WATER PERMIT NO. 2757-2

SOUTH DAKOTA
WATER PERMIT NO. 2757-2

We have reviewed the plans and specifications for your dam project located between the NE $\frac{1}{4}$ NW $\frac{1}{4}$ and NW $\frac{1}{4}$ NE $\frac{1}{4}$ of Section 21-T5N-R19E, in Haakon County. The plans and specifications for the reconstruction of the dam are approved. Approval of the plans and specifications does not authorize reconstruction of the dam. The reconstruction of the dam may not begin until Water Permit No. 2757-2 is approved.

REPORT ON
WATER PERMIT APPLICATION No. 2757-2
Henry Hanson
September 14, 2016

HENRY HANSON
378 POND
PROFILES AND CROSS-SECTIONS OF DAM AND AUXILIARY SPILLWAY
Horton County, South Dakota
NE 1/4 Sec 21 T5N R19E

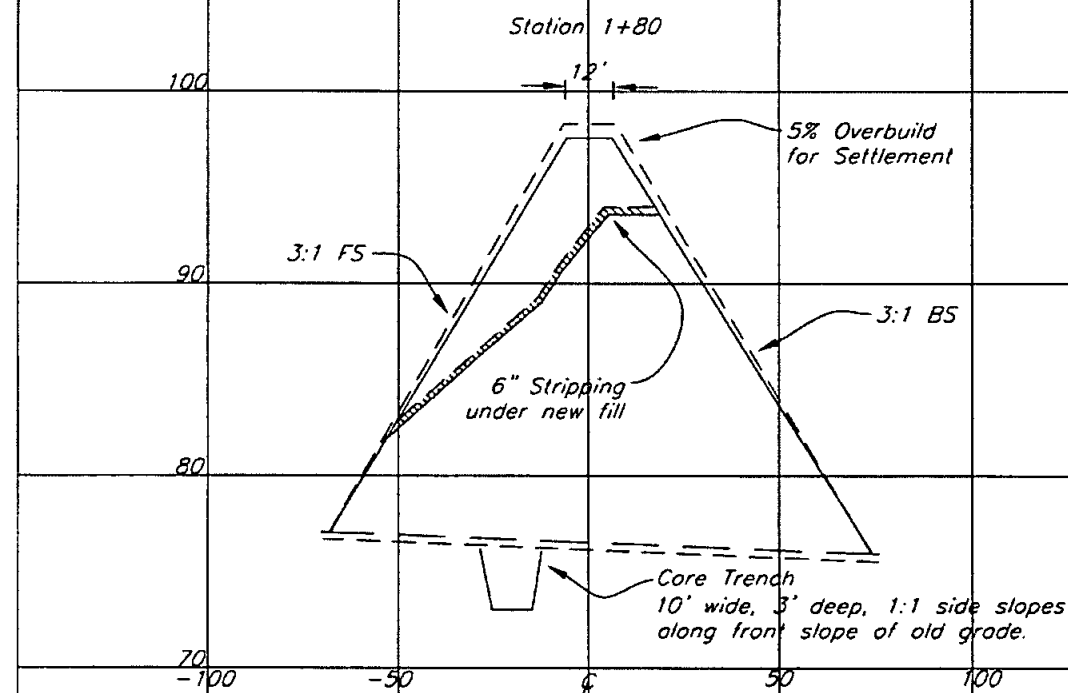
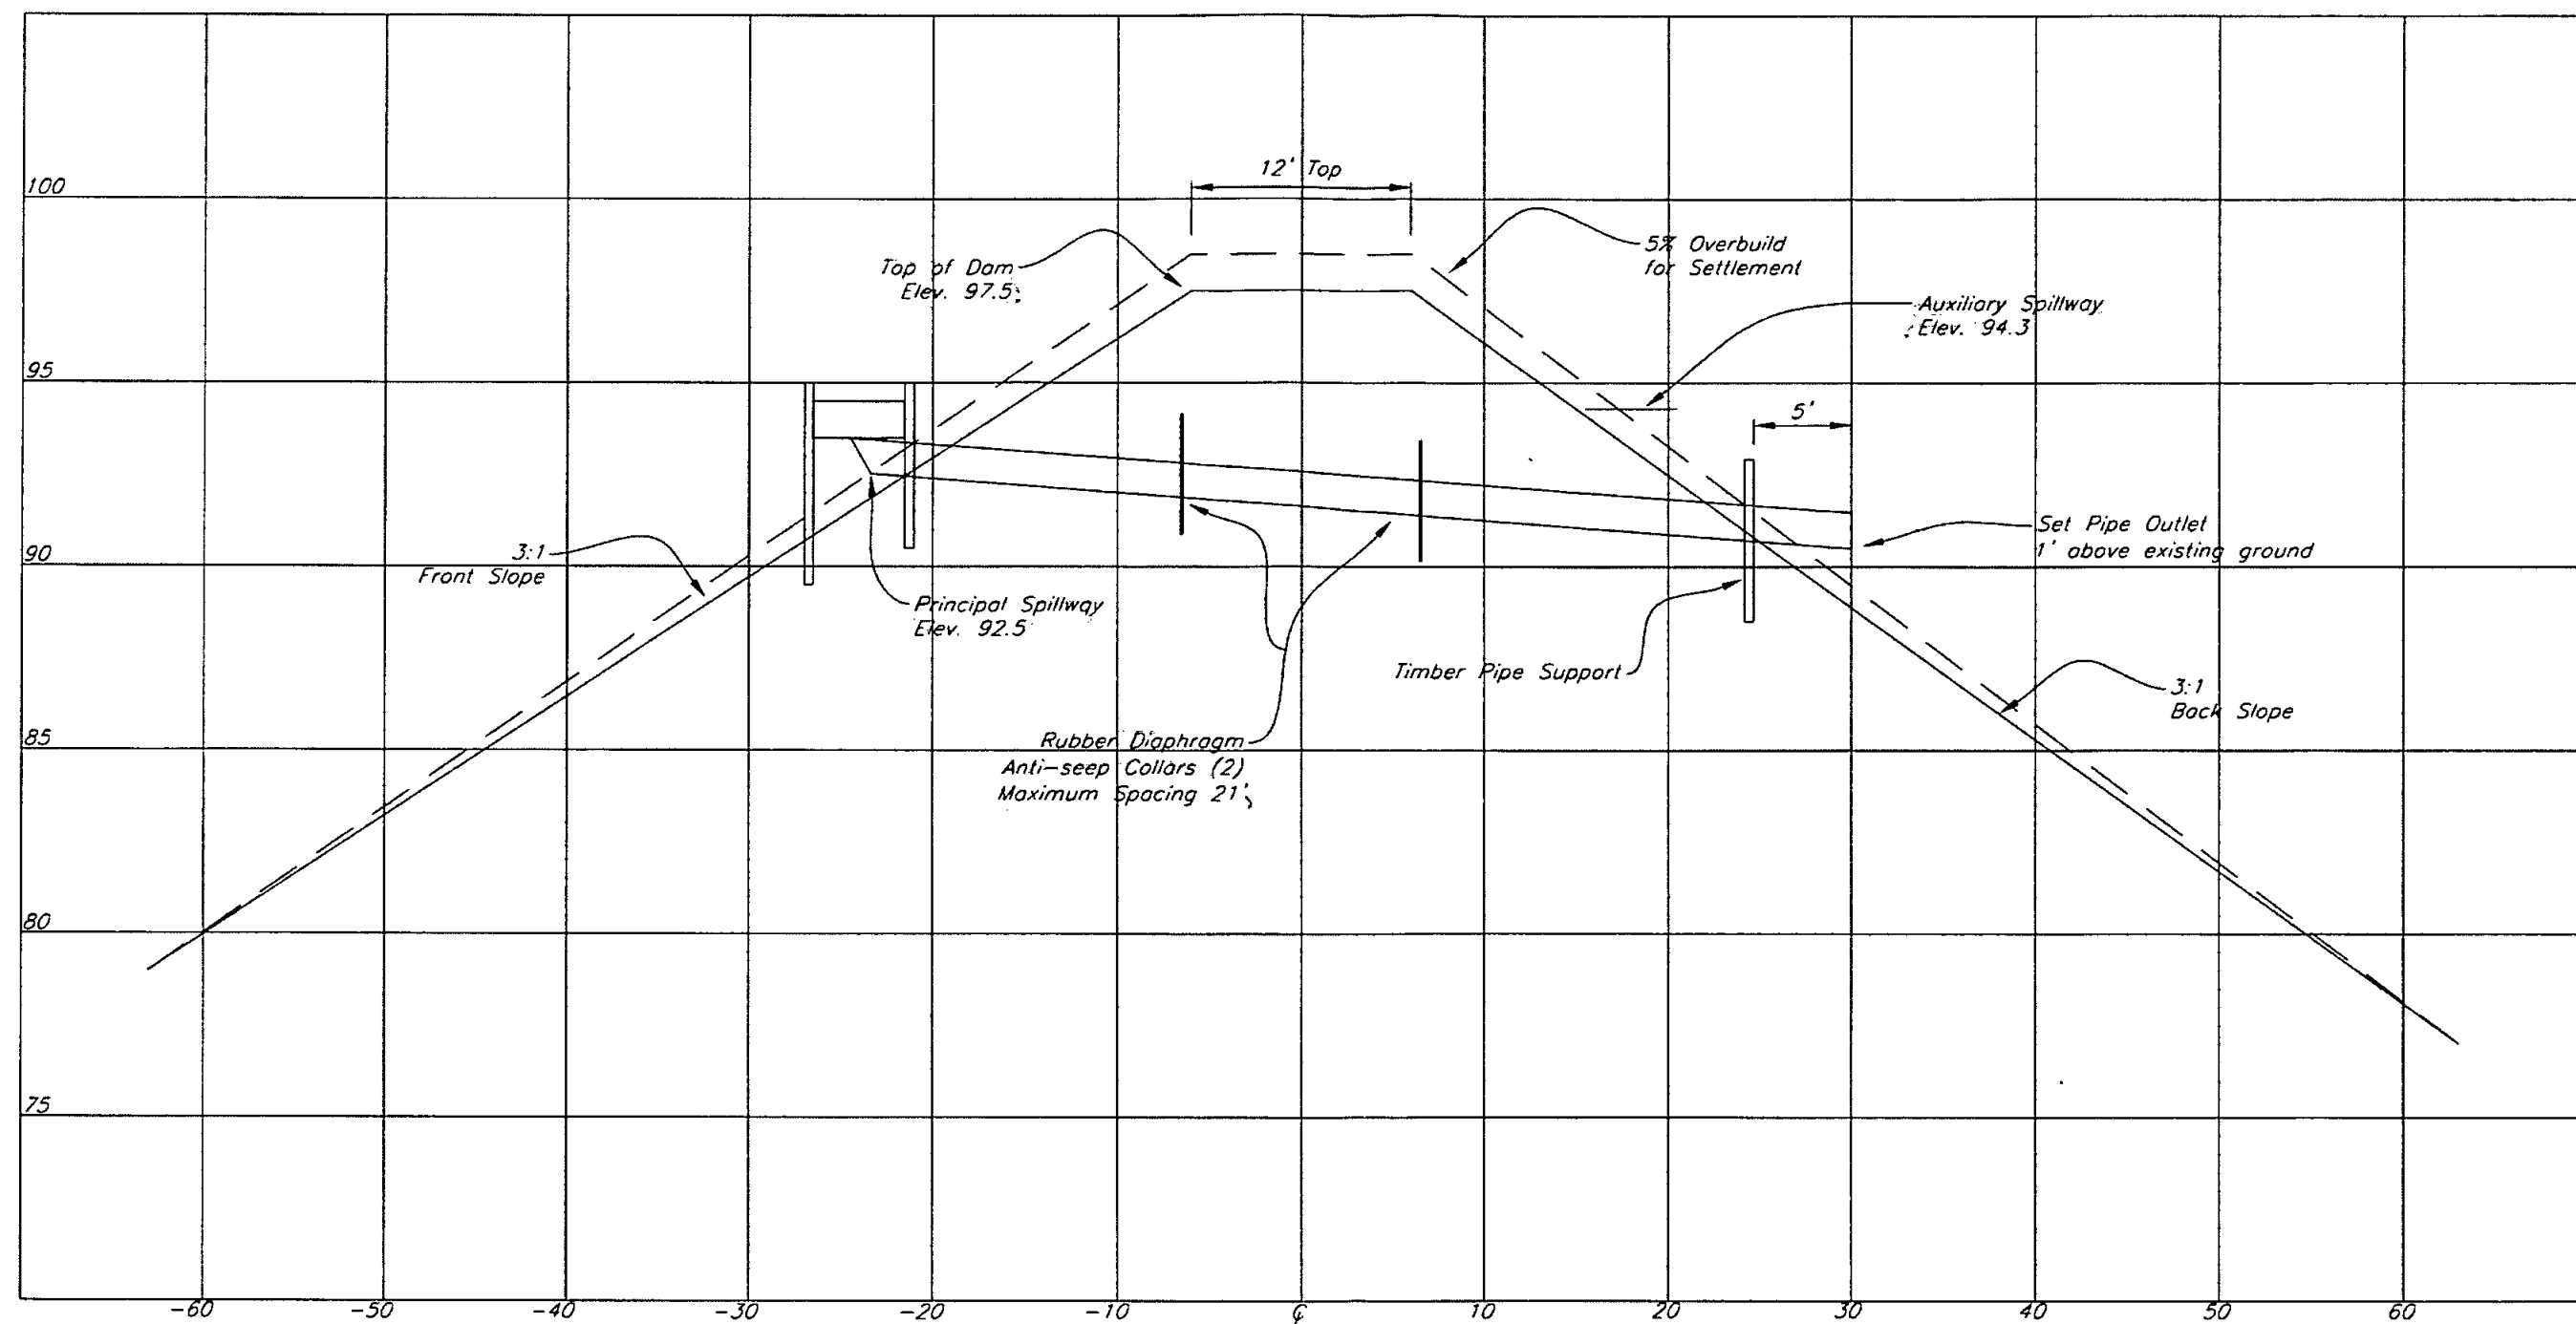
Secondary Spillway Capacity

$$Q = CLH^{7/2}$$

$$C = 2.6 \quad L = 40 \quad H = 3.2$$

$$= 2.6(40)(3.2)^{3.5}$$

$$= \underline{585 \text{ cfs}} \quad (\text{NRCS had } 963 \text{ Open Channel})$$
